**m e m o r a n d u m**

**SUBJECT:** DRB-2015-01: A request by Kevin Hunsinger to review the site plan and design of 611 West Elm Street in the MOR, Mixed Office Residential Zoning District.

1 SITE PLAN  
91 SCALE: 3/32" = 1'-0"

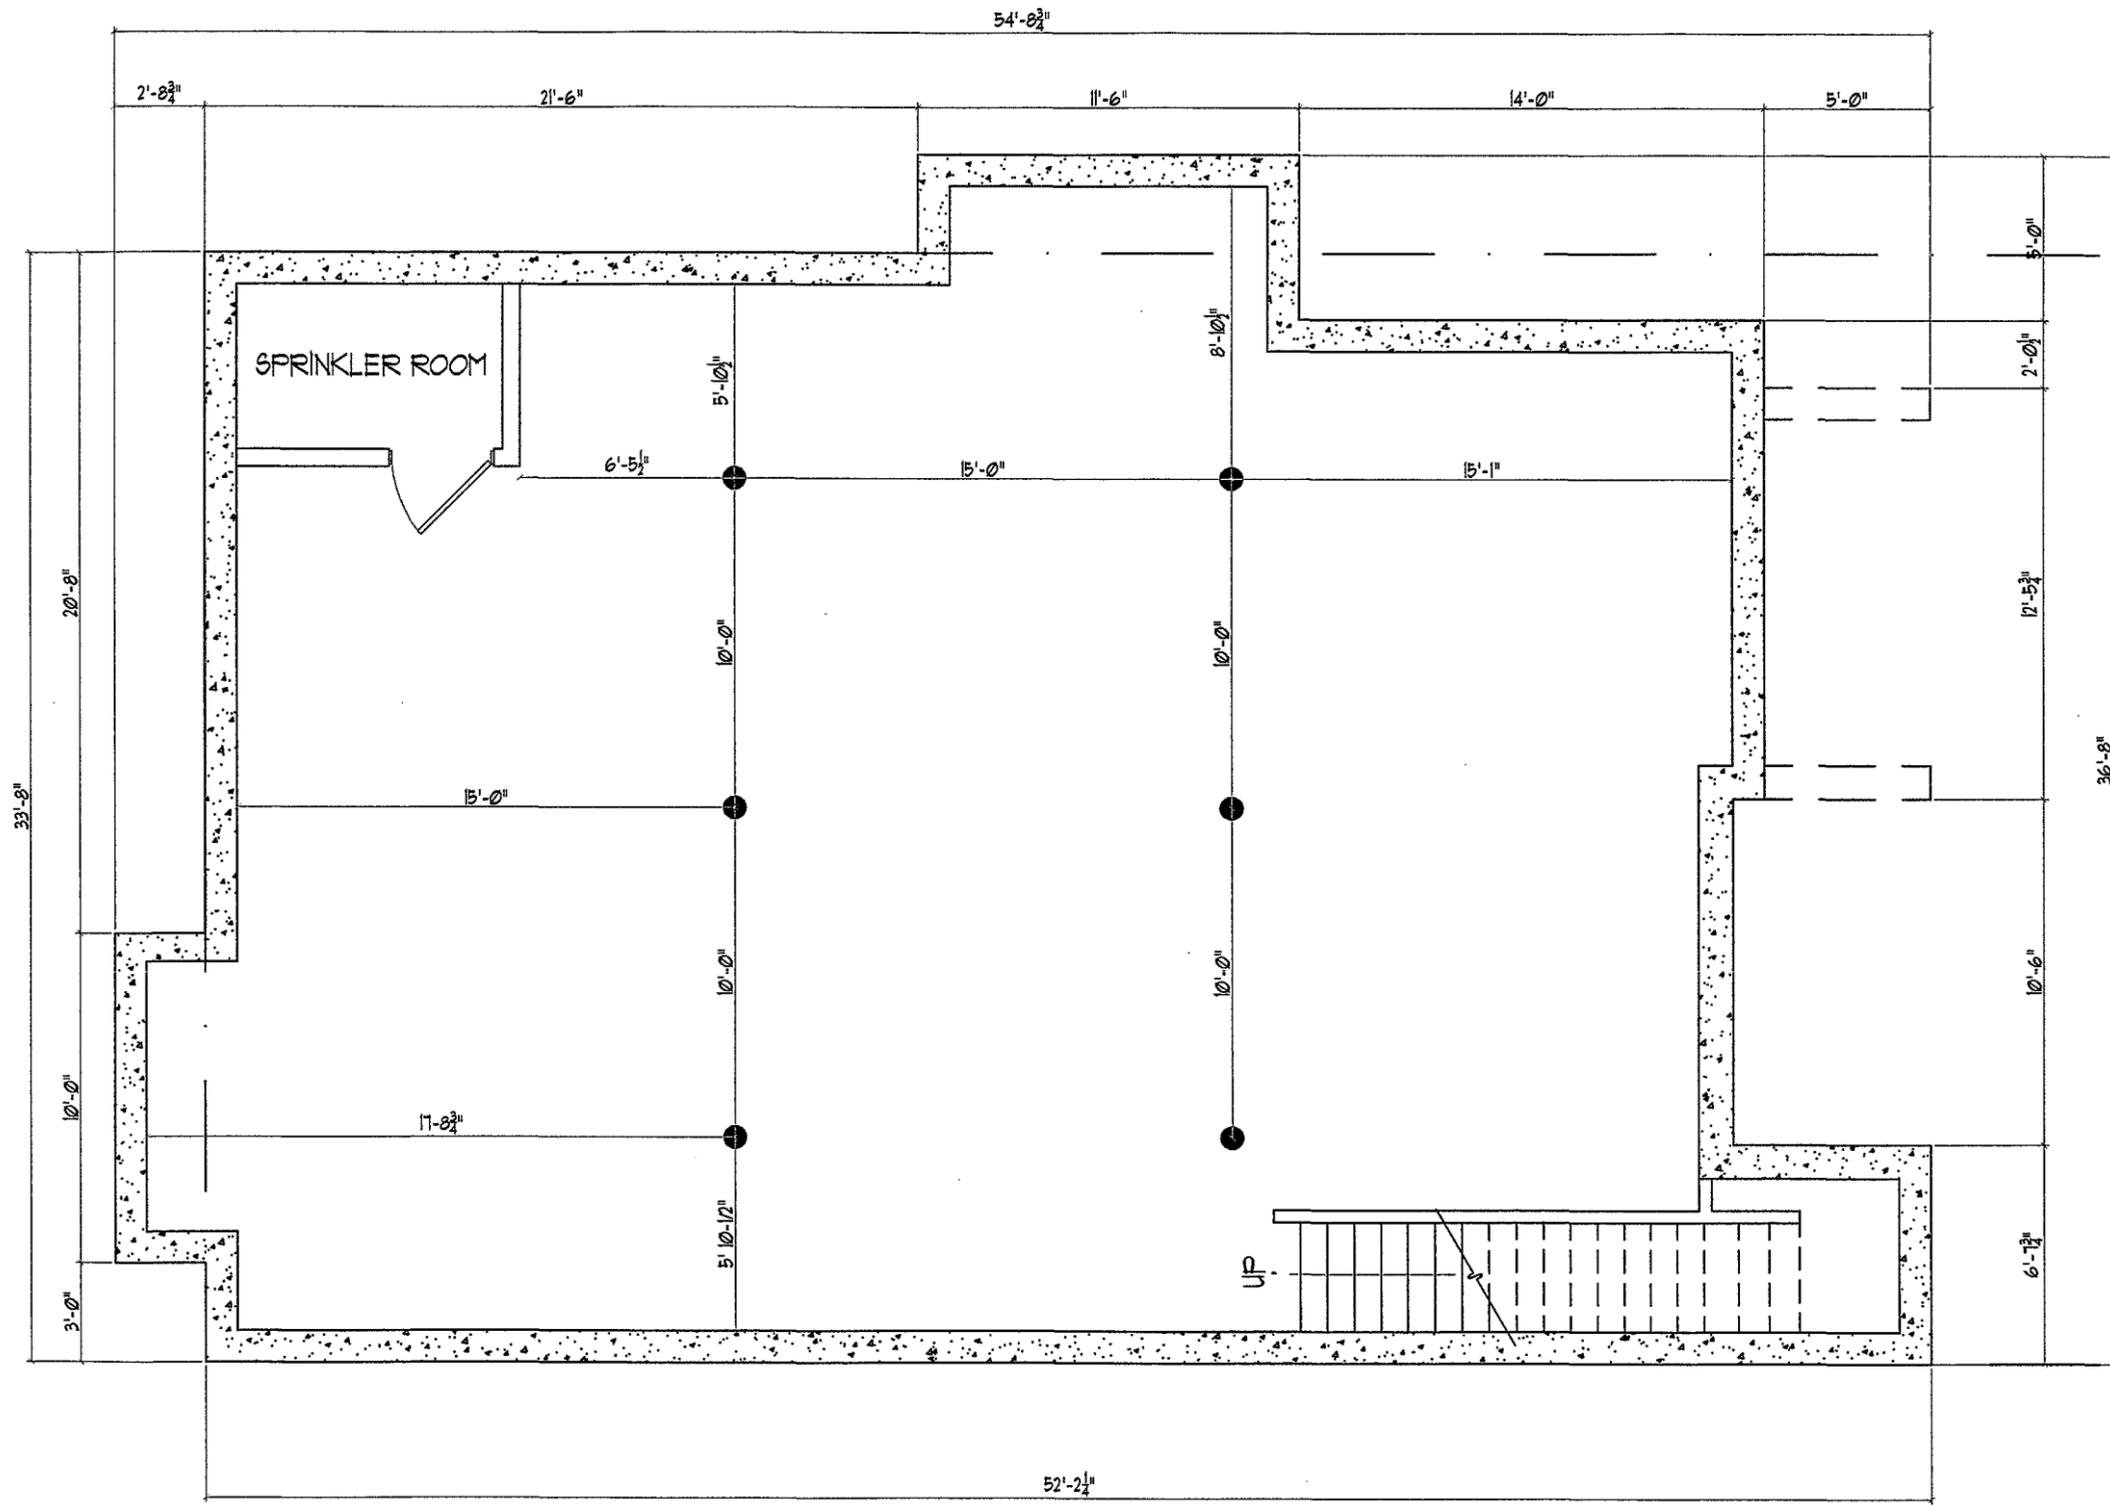
*A new paved parking area would replace the existing garage. The parking area would be behind the rear face of the building and will be accessed from Coler Avenue. The proposal includes a new six-foot privacy fence to screen the parking area from the single-family residences to the west and south. The petitioner has indicated that the fence will be PVC-clad. The parking area would be located behind the structure, as is compatible with the pattern of the neighborhood. There is one parking space shown on the site plan that is not completely behind the rear face of the building. This space will either require a variance for the proposed location or the applicant would provide off-site parking, within 600 feet of the site as an alternative.*

***City staff recommends that the MOR DRB find that the proposal meets the design guidelines for Parking Areas, with the condition that parking space number five be relocated to within 600 feet of the site or that a variance be obtained to allow it in the location shown on the site plan.***

*The applicant will be submitting a detailed landscape plan prior to the MOR DBR hearing. There are four mature trees on the site and two adjacent mature trees in the city-owned right-of-way along Coler. The proposed site plan shows two trees on the site and one of the street trees to remain. The City Arborist has inspected the street trees and believes the tree to be removed should be replaced elsewhere, as it is in poor health and located directly under power lines. The loss of mature trees on the southern portion of the site is not ideal, but the requirements for five parking spaces and the requirement that parking be located behind the building leave no other option. The applicant is proposing to remove the existing overgrown shrubbery along the southern edge of the parcel and to replace it with a screening fence.*

***City staff recommends that the MOR DRB find that the proposal meets the design guidelines for Landscaping with the condition that added shrubs be planted outside of the fence along the west and southern facades to soften the impact of the development.***

3. Parking space number five shall be relocated to another location within 600 feet of the site or the applicant shall obtain a variance to allow it as shown on the site plan.
4. The applicant shall obtain a variance to allow for the reduced side yard along the eastern property line.
